# RECOMMENDED SERVICE BULLETIN NO. RSB 42-072/2

Application of an improved sealant on the fire sensors or replacement by a sealed fire sensor

# WORK INSTRUCTION WI-RSB 42-072

# "Fire Sensor Water Protection"

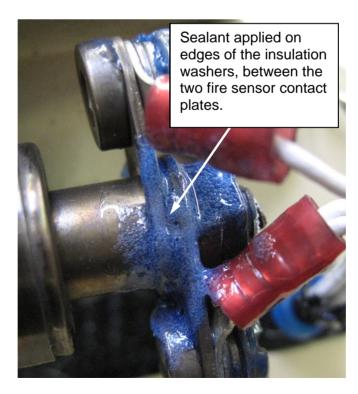
1	Remove the upper and lower cowling on LH and RH engine.
2	Clean the rear of the fire sensors with an Isopropyl alcohol based cleaner (in particular the area of the insulation washers of the sensors).
	<b>CAUTION</b> : When handling chemicals always obey the Health and Safety instructions given by the manufacturer.
3	Let the cleaned area dry for about 30 minutes.
4	Apply the sealant onto the edges of the insulation washers of the fire sensors. Ensure that the washers are covered with the sealant completely. This will make the fire sensor water resistant and therefore avoiding inadvertent fire sensor triggering. See picture below.
